## **Planning Commission Staff Report**

**Project Type:** Amended Architectural Elevations

**Description:** **MPD Investments, Adjusted Lot 2 (Beyond Self-Storage at Chesterfield) - AAE:** Amended Architectural Elevations and Architect's Statement of Design for a 2.99 acre tract of land zoned "PI" Planned Industrial District located north of North Outer 40 Road, west of its intersection with Boone's Crossing.

**ARCHITECT'S STATEMENT (Revision of Oct 3, 2016 Statement, added information in *italics*)**

**A204**

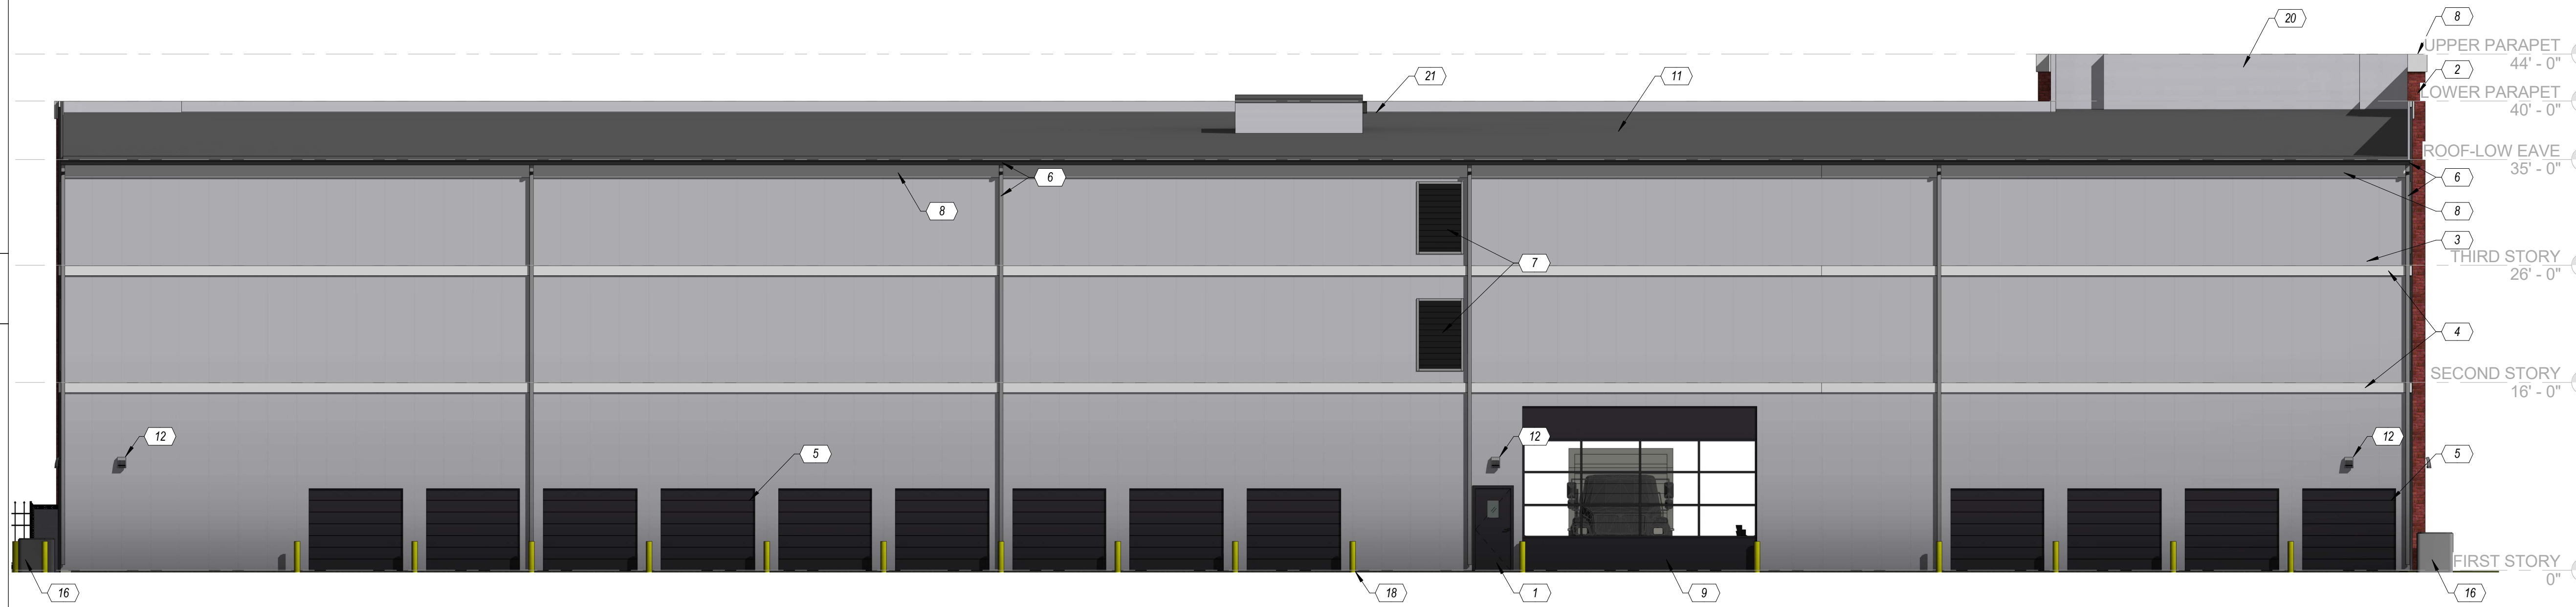
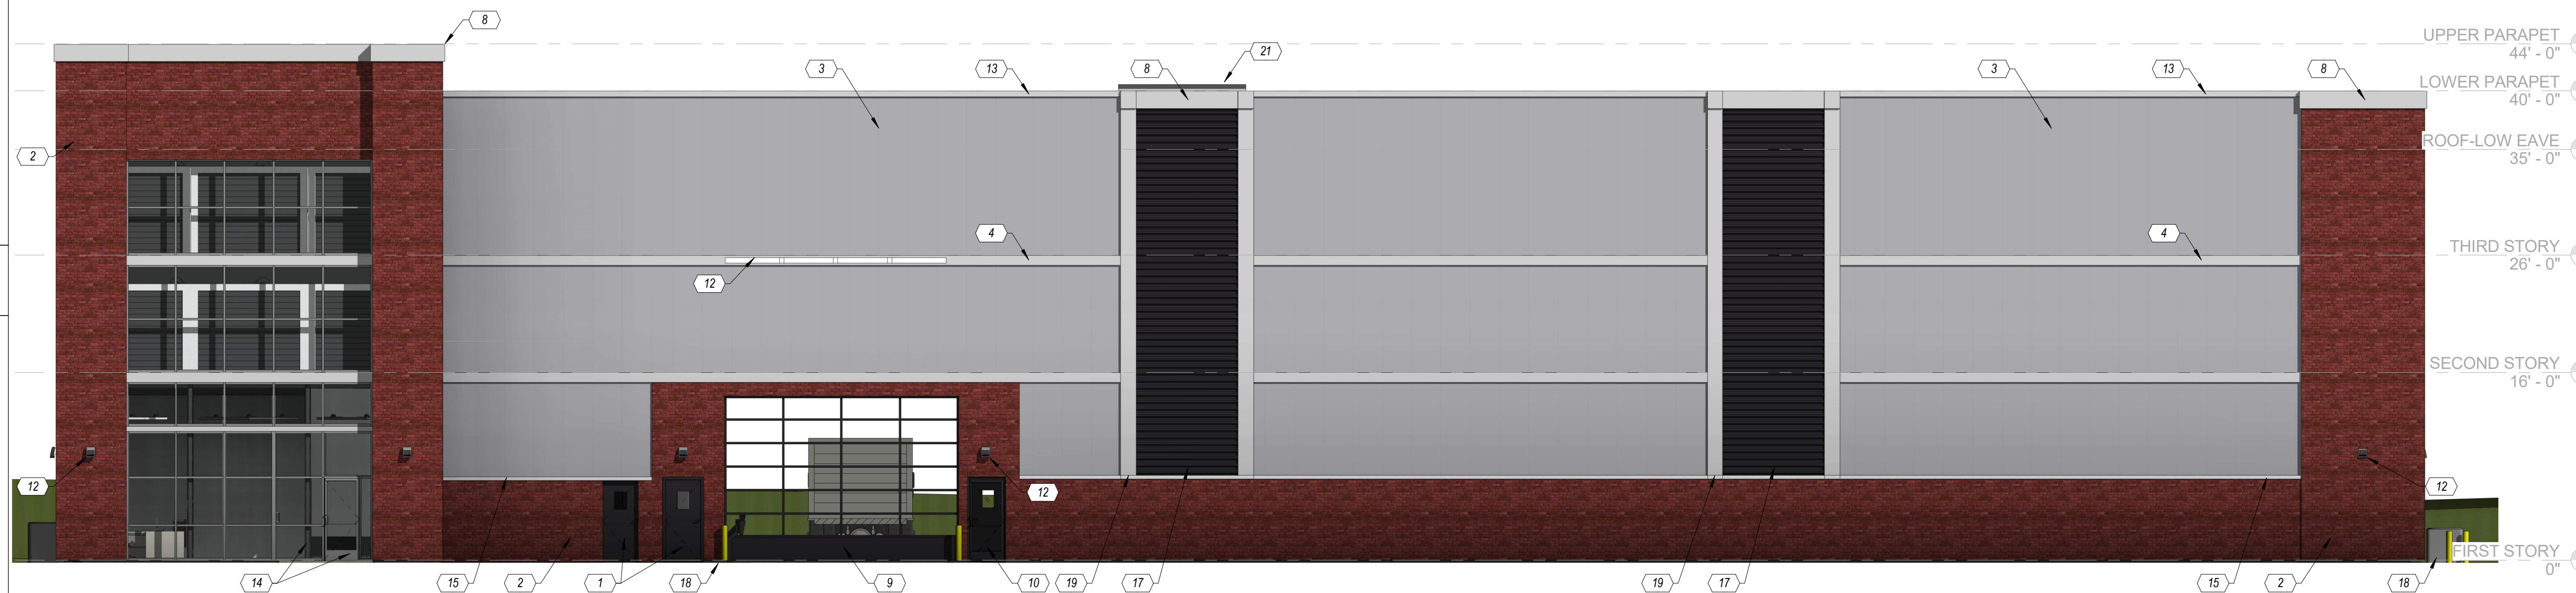
The proposed change replaces the previously approved brick with a Nichiha Brick panel. This change is noted on the elevations by replacing the keyed symbol for the material to reference the new brick panel.

During the original approval for the project, it was recommended that the height of the brick be increased to the level shown on the submitted elevations from the originally submitted height of 3 feet. The applicant has included a rationale for the change to the material citing the structure of the wall system is unable to hold the additional weight of the thin brick. The proposed Nichiha brick panel system was chosen to replicate the aesthetic of the brick while reducing the weight.

The original request showed all mechanical equipment located in one area along the western side of the building with screening provided by existing and proposed landscaping. The revision shows mechanical equipment being split into several areas along the building. To ensure compliance with the UDC, the applicant has indicated they will be installing additional landscaping adjacent to all mechanical equipment consistent with the original improvement.
